Our Northern Runway: making best use of Gatwick

Highway Improvement Changes and Project Update

CONSULTATION DOCUMENT

Summer 2022

Figure 2.3 : Proposed South Terminal Roundabout improvements

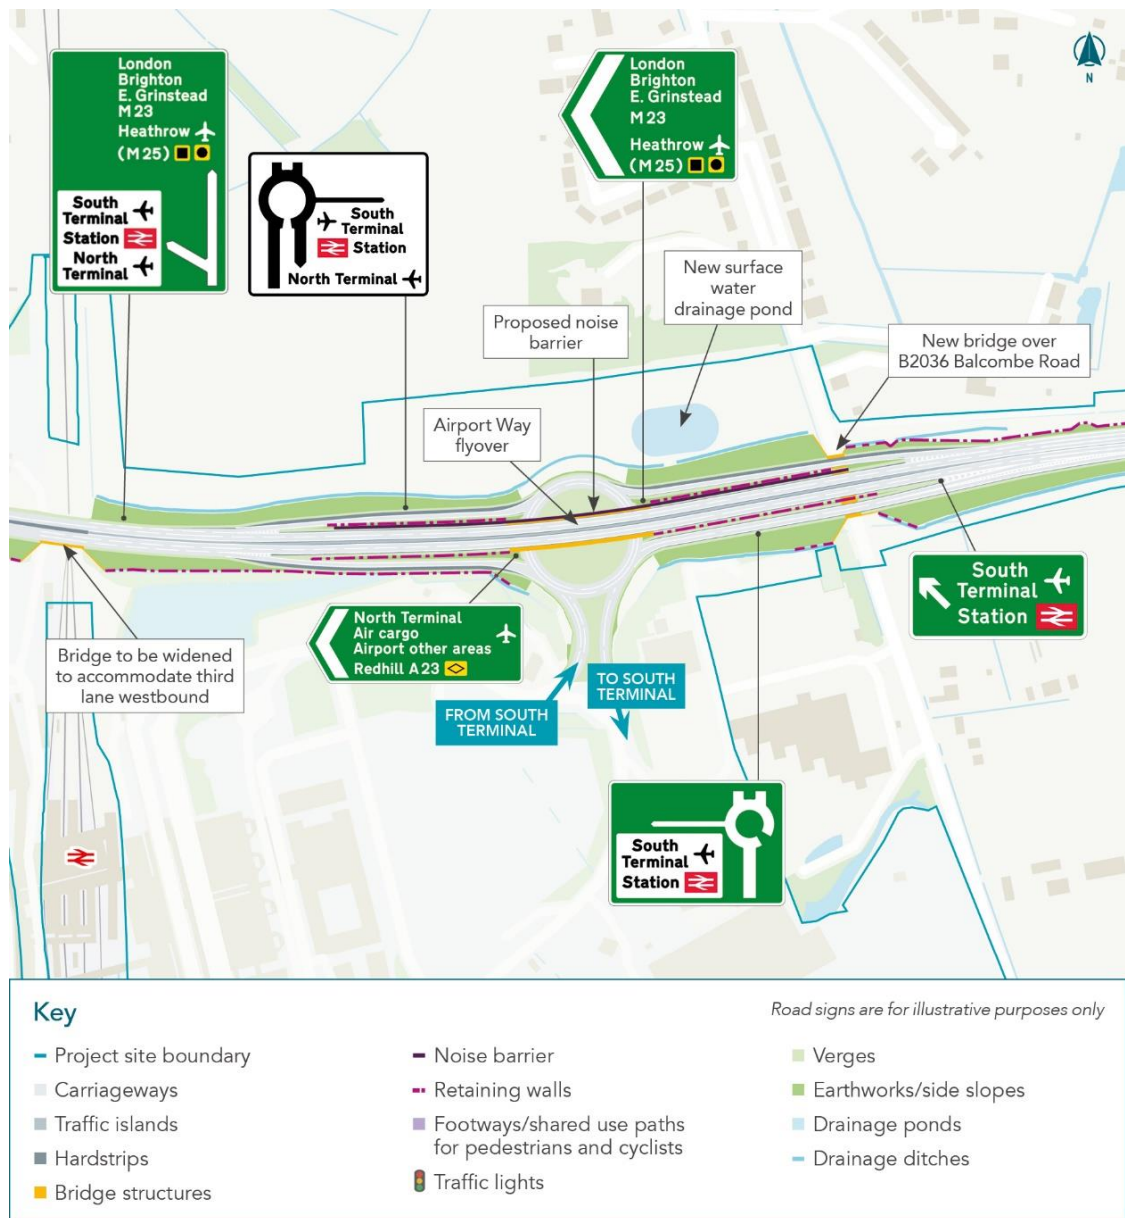
2.3.2 The proposals for South Terminal Roundabout are similar to those presented in the Autumn 2021 Consultation. This assumes a new east-west flyover carrying traffic to and from M23 Junction 9. Minor design amendments have been made to the westbound on-slip to reflect the changes to Airport Way (to provide additional resilience and accommodate potential traffic growth). A new

drainage pond is still envisaged as a permanent feature to the north-east of the roundabout. We also propose to use part of the land north of the roundabout as a temporary construction compound, which would require an additional temporary northern arm off the roundabout. The construction of the new slip roads connecting to the east of the roundabout and extending over Balcombe Road (the eastbound on-slip and the westbound off-slip) both require temporary land take for construction and permanent diversion of rights of way - see Figures 2.1B and 2.1C and Figures 2.3A to 2.3D in **Appendix 4**. These diversions would be minimised and set out as part of the wider rights of way strategy. The existing Balcombe Road bridge structure would be replaced with a new structure to accommodate the proposed M23 spur and slip roads at this location. The proposals are illustrated in Figure 2.3 below:

- 2.3.3 **Summary of changes since Autumn 2021 Consultation:** The changes made to the westbound on-slip would necessitate more substantial modifications to an existing pond on airport land south of Airport Way, which would be carried out as part of the Project. We have been able to refine and reduce the amount of land proposed for temporary access on the north side of the road either side of the roundabout for utilities and construction access. We have further refined our proposals for using part of the land north of South Terminal Roundabout as a temporary construction compound and this is reflected in a revision to our Project site boundary (see **Appendix 3**).

Figure 2.4: Proposed North Terminal Roundabout improvements

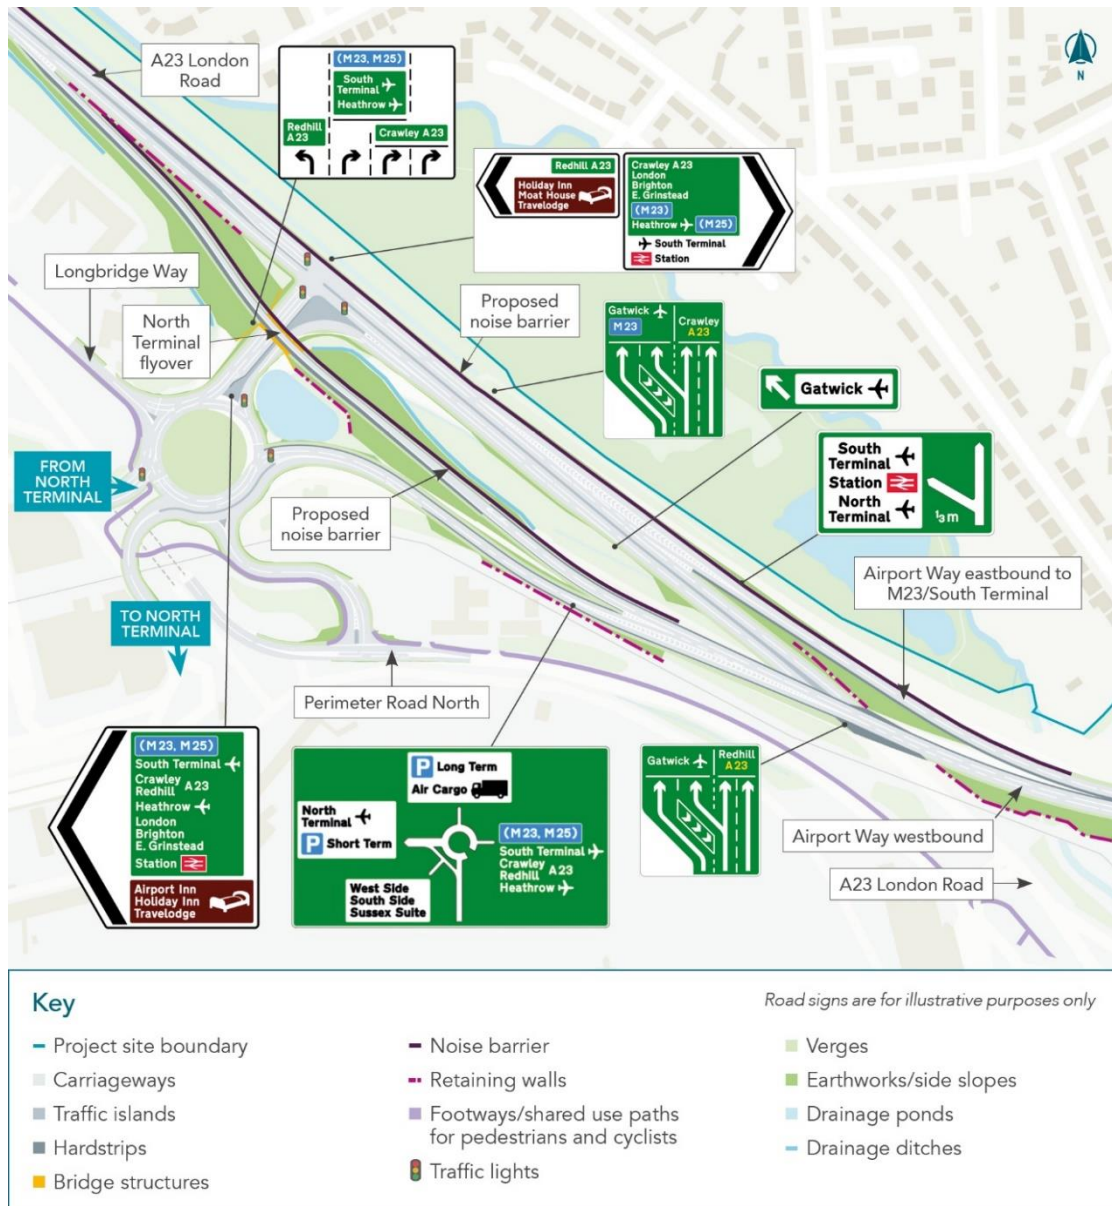
- 2.3.9 The proposed layout for North Terminal Roundabout has undergone the greatest change since the Autumn 2021 Consultation. A number of questions and concerns were raised about the complexity of the proposed layout so we undertook a complete review of all potential solutions in consultation with National Highways and local highway authorities. This review balanced safety and operational considerations, reflected in design guidance, with the physical constraints at this location, and the potential land, community and environmental impacts, particularly those on the Riverside Garden Park area. One of the fundamental aims during this redesign of the junction solutions was to improve capacity and performance by separating airport and non-airport traffic whilst limiting any increase in land take outside the highway boundary.

- 2.3.10 We propose to keep the westbound flyover connection between Airport Way and Longbridge Roundabout but the signalised junction layout proposed in the last consultation has been replaced by a more conventional roundabout design, similar to that which exists now but with some arms removed or relocated. The roundabout would have a slightly larger diameter to increase its capacity and the existing eastbound Airport Way exit has been replaced with a connection via a new signalised junction with the A23 London Road. Links to and from the A23 have also been redesigned. These changes make the roundabout operation more efficient but also retain the direct route from North Terminal south towards Crawley from the previous proposal, which removes the need for u-turning at Longbridge Roundabout. Alongside the revised layout an additional drainage pond would be provided to take surface water run-off from the highways. The improved junction layout would remain largely within the existing highway boundary, with some additional land-take impacts on the south side of the road to accommodate the new westbound flyover carrying traffic towards Horley, as noted in the Project Site Boundary Plan in **Appendix 3**. This flyover would include a noise barrier along the elevated section and this was described in the original PEIR. The proposed design, including the locations of the proposed noise barriers, is illustrated in Figure 2.4 below:

2.3.11 Summary of changes since Autumn 2021 Consultation: The junction layout at North Terminal has been revised to a more conventional roundabout solution, with changes to entry and exit routes. As well as simplifying the final layout, the revised scheme would make it easier to sequence the works whilst minimising the impact on the existing network. There would be considerable loss of vegetation from within the highway boundary, which would be replaced. We are reviewing how and where this can best be achieved within the new highway layout, noting the requirement for new drainage ponds and the structural work supporting the new flyover. The flyover would cross the new link between North Terminal Roundabout and the A23, passing north of the Premier Inn and petrol station located on Longbridge Way. Some alteration to the existing bund behind these facilities would be required to accommodate the earthworks supporting the flyover.

Figure 3.1 : Updated Car Parking Locations (since Autumn 2021 Consultation)

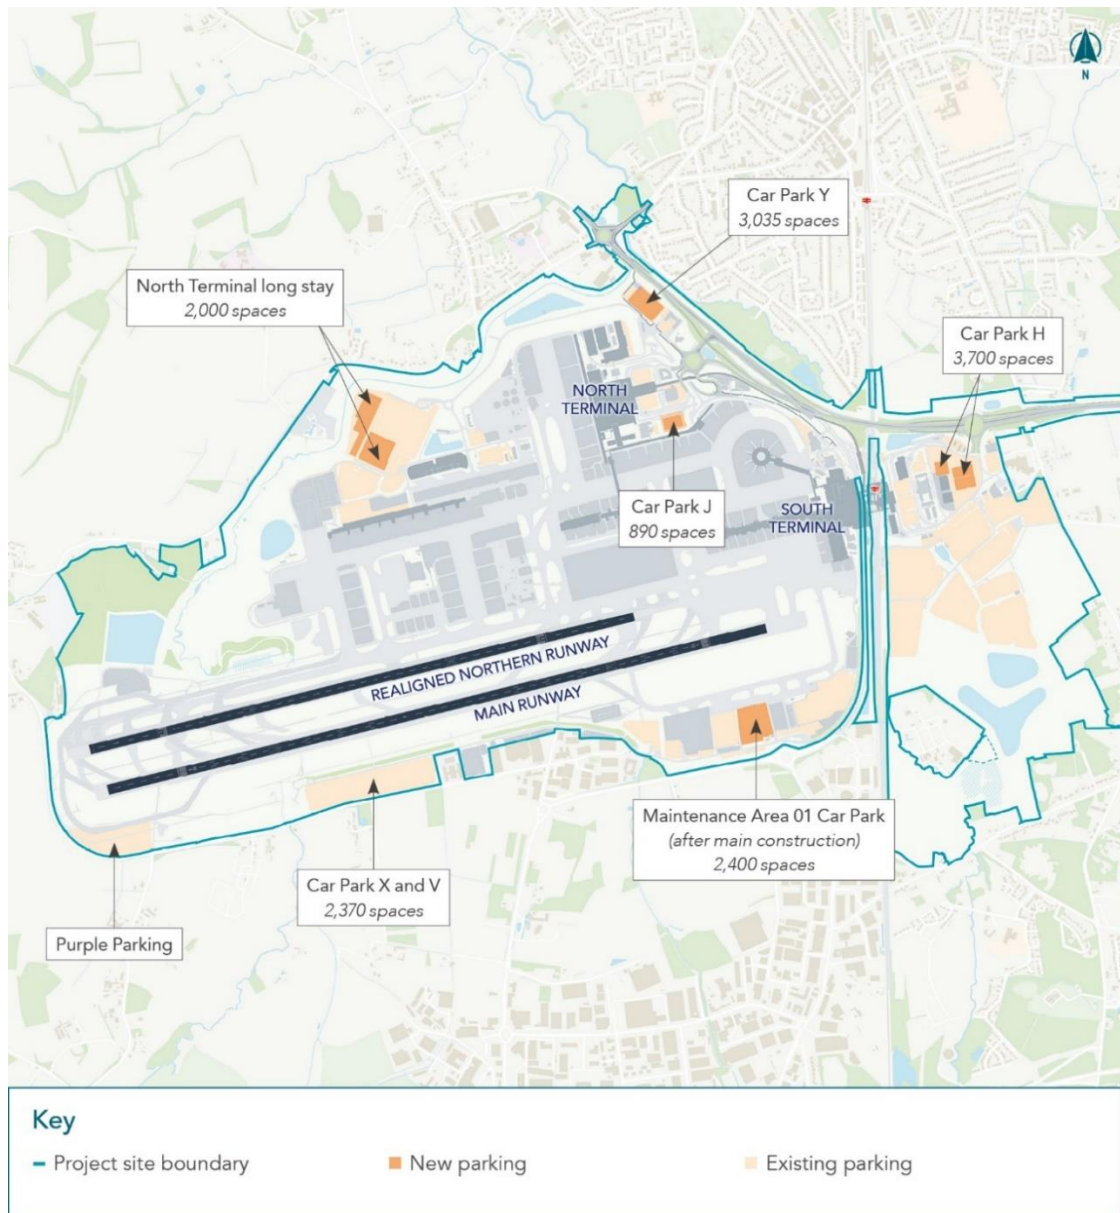
3.2.9 This means that within the NRP DCO application we would only seek permission for up to an additional 12,025 spaces, of which 7,780 would replace spaces permanently lost from the airport. This translates into an overall increase for the Project of 4,245 spaces to cater for passenger growth, which is a significant reduction compared to our Autumn 2021 Consultation proposals. This leads to a significant drop in the number of parking spaces provided per million annual passengers for the NRP compared to either the 2019 Baseline (pre-pandemic) or the Future Baseline, which is consistent with our approach to sustainable travel. As a measure, using only on-airport spaces, this trend is illustrated as follows:

3.2.10 As part of this consultation, we are seeking views on whether we should continue to include, within our parking proposals for the Project, the identified 3,300 spaces that may be needed to replace off-airport unauthorised spaces and which are included in the revised parking proposals discussed above.

Figure 3.2 : Location of the two possible locations for the CARE facility (as shown in PEIR)

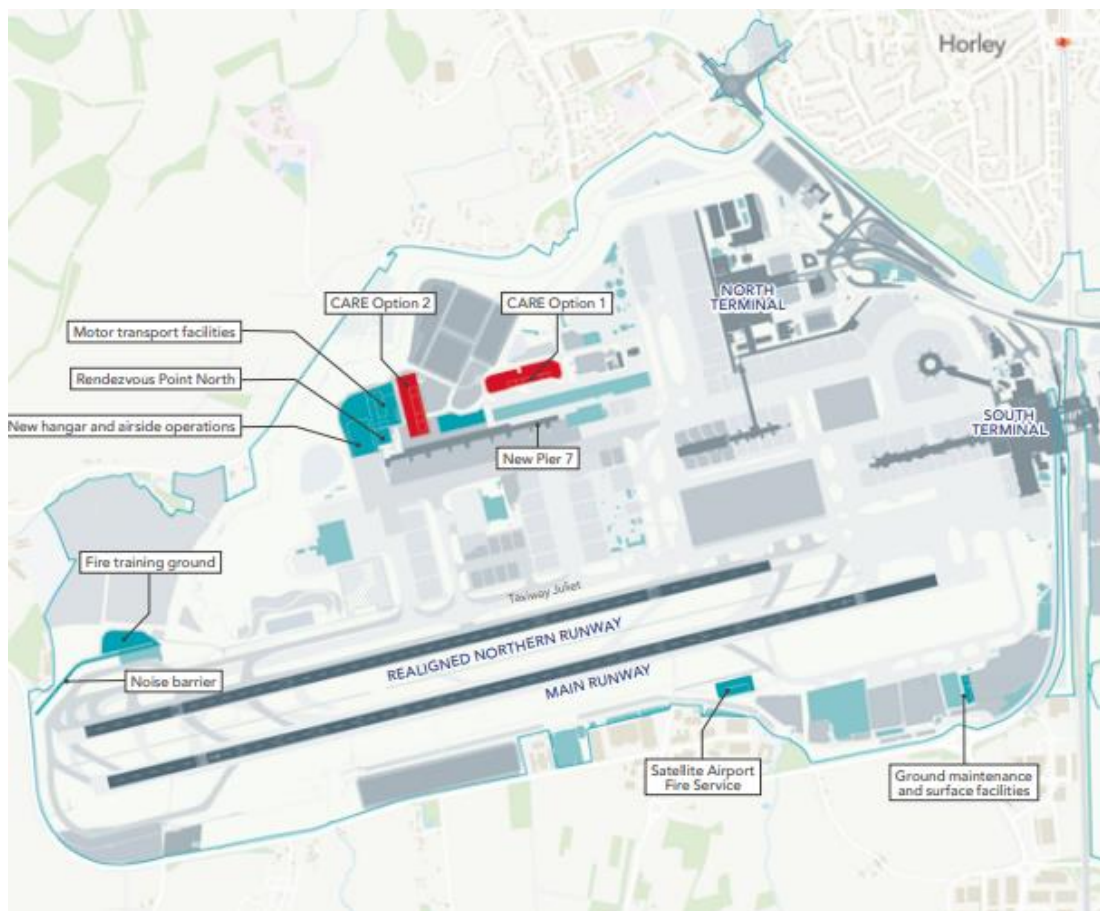
- **Central Area Recycling Enclosure Facilities (CARE)** – in the Autumn 2021 Consultation, we identified two possible locations for the new CARE facility. The existing facility north of Taxiway Juliet would need to be relocated and expanded as part of the Project. The two proposed sites for the new facility were both located in the north-western part of the airport (see Figure 3.2). In the Autumn 2021 Consultation, we asked respondents which location would be preferred and why:

Following the Autumn 2021 Consultation, Option 1 has been selected. Respondents preferred its central location, noting the shorter journey from the central terminal areas where the bulk of our waste originates and its relative remoteness from the airport boundary. We will now progress the design for this building which we expect would be up to 22m in height above ground level with a biomass boiler flue height of up to 50m above ground level and a total footprint of approximately 17,550m².

Figure 3.3 : Revised hotel and office locations

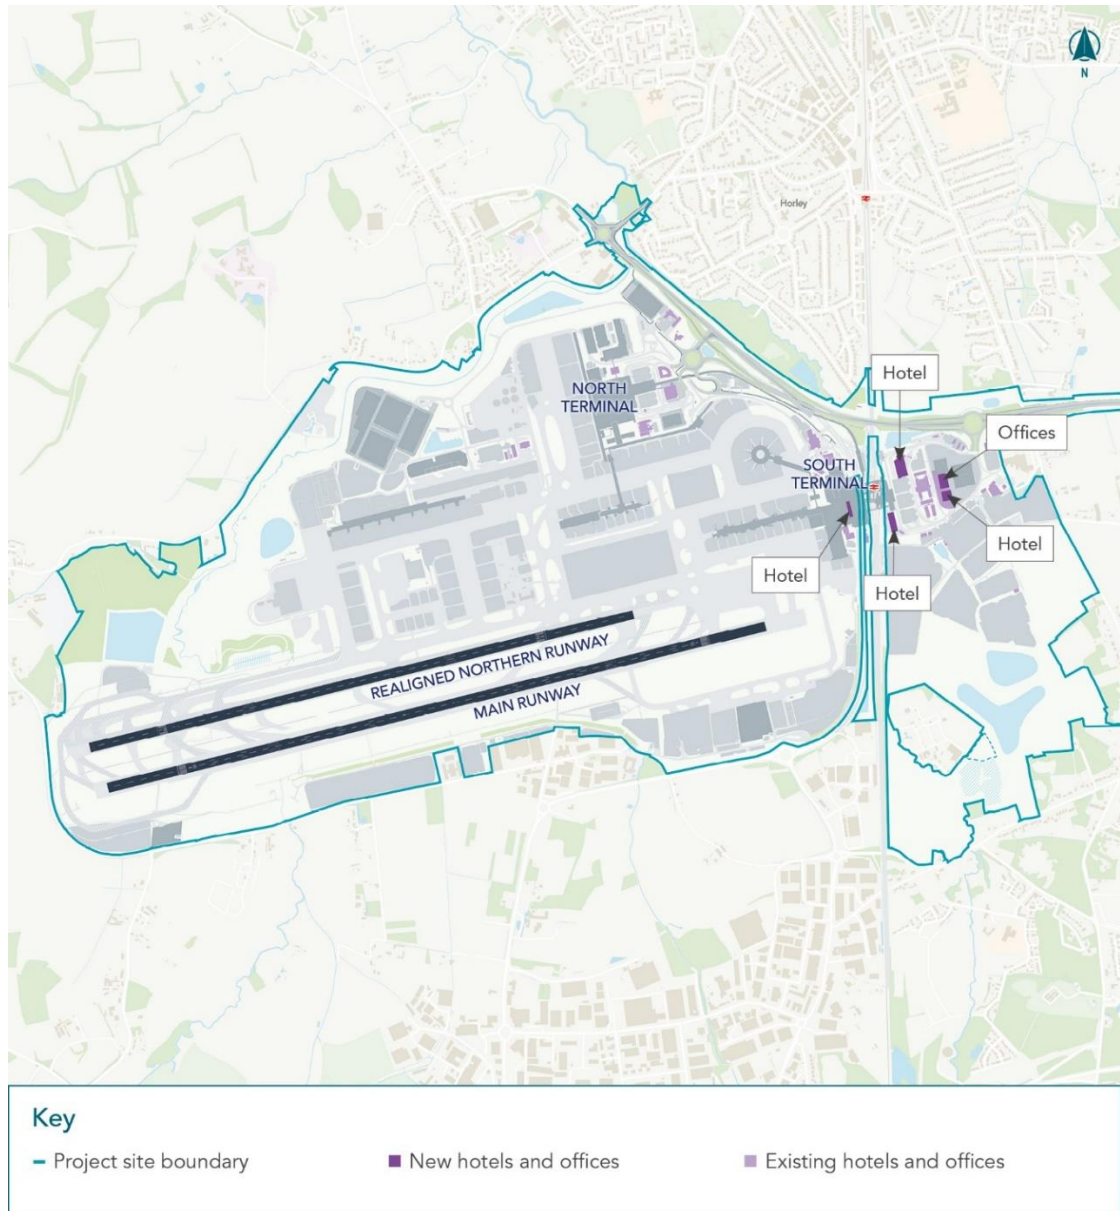
- 3.5.6 Based on the updated assessment, our updated hotel proposals now comprise 1,250 additional bedrooms in four new hotels in South Terminal (see Figure 3.3) (totalling 250 additional bed spaces from the Autumn 2021 Consultation):

- 3.5.11 However, we propose to convert the existing Destinations Place at South Terminal from an existing office into a new hotel. This building is currently occupied by our staff and the loss of this existing on-airport office floorspace would generate the need for one new office block. The exact configuration, phasing and amount of floorspace would depend on the actual timing of requirements. The proposed location for the new office block is shown in Figure 3.3:

Figure 3.4 : Surface and foul water improvements

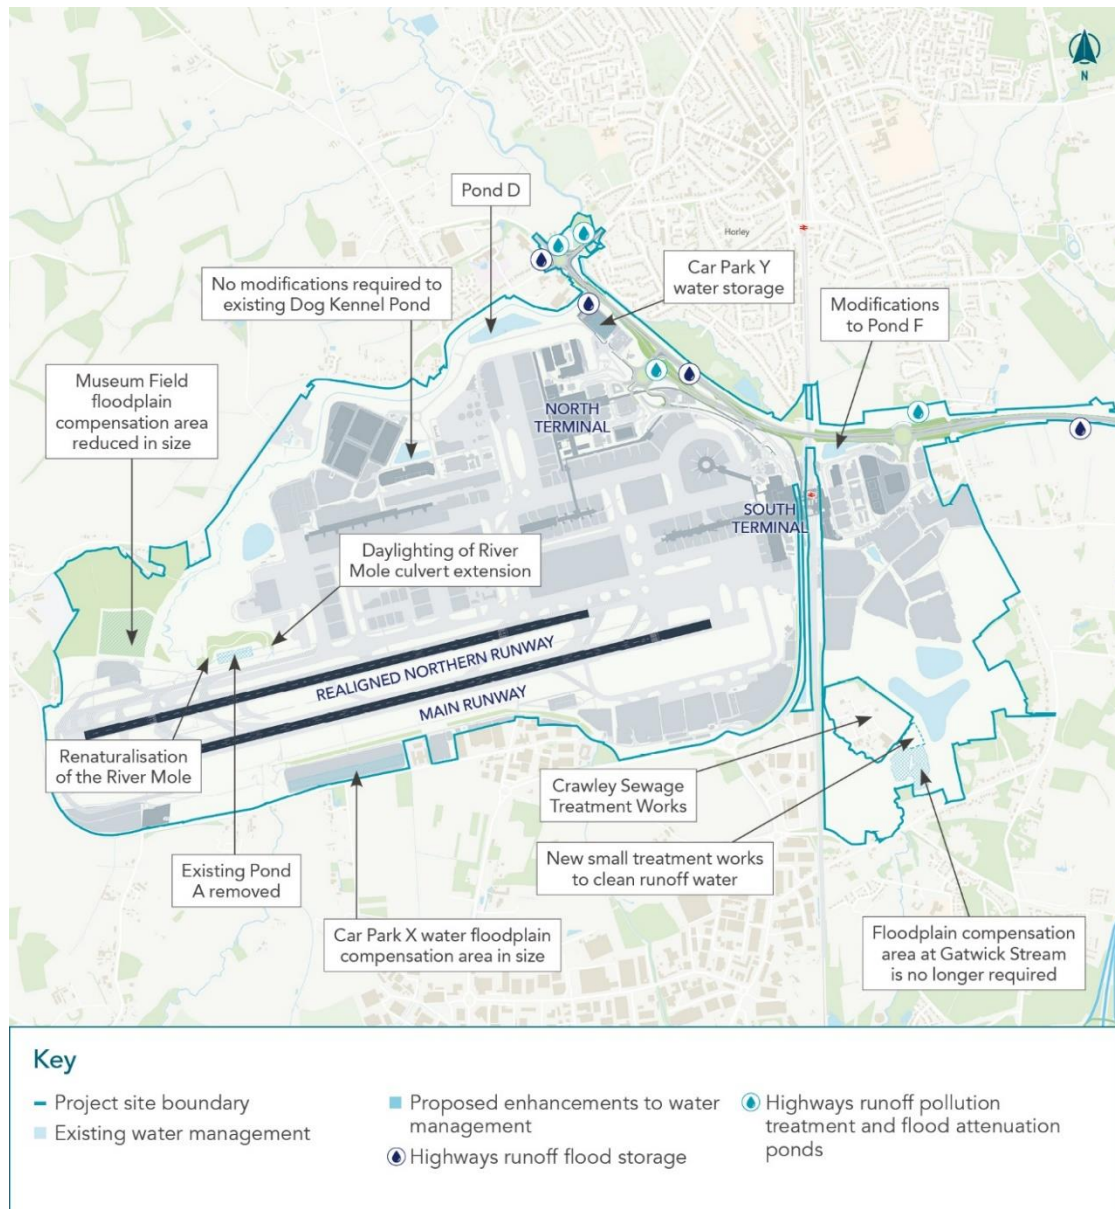
3.6.3 This has resulted in the following changes to the infrastructure required from that discussed in the PEIR (see Figure 3.4):

3.6.6 Updated computer modelling undertaken to understand surface water flood risk, and pollution control has shown that there would be overall improvements in water quality at the main discharge from Pond D to the River Mole if there was additional treatment of water at the pollution storage lagoons. Accordingly, Gatwick will be discussing with the Environment Agency the proposed installation of a small treatment plant on the site of the former Rolls Farm, to the east of

Crawley Sewage Treatment Works. The new plant would treat a proportion of the water stored in the lagoons and either discharge it to the Gatwick Stream or to the airfield.
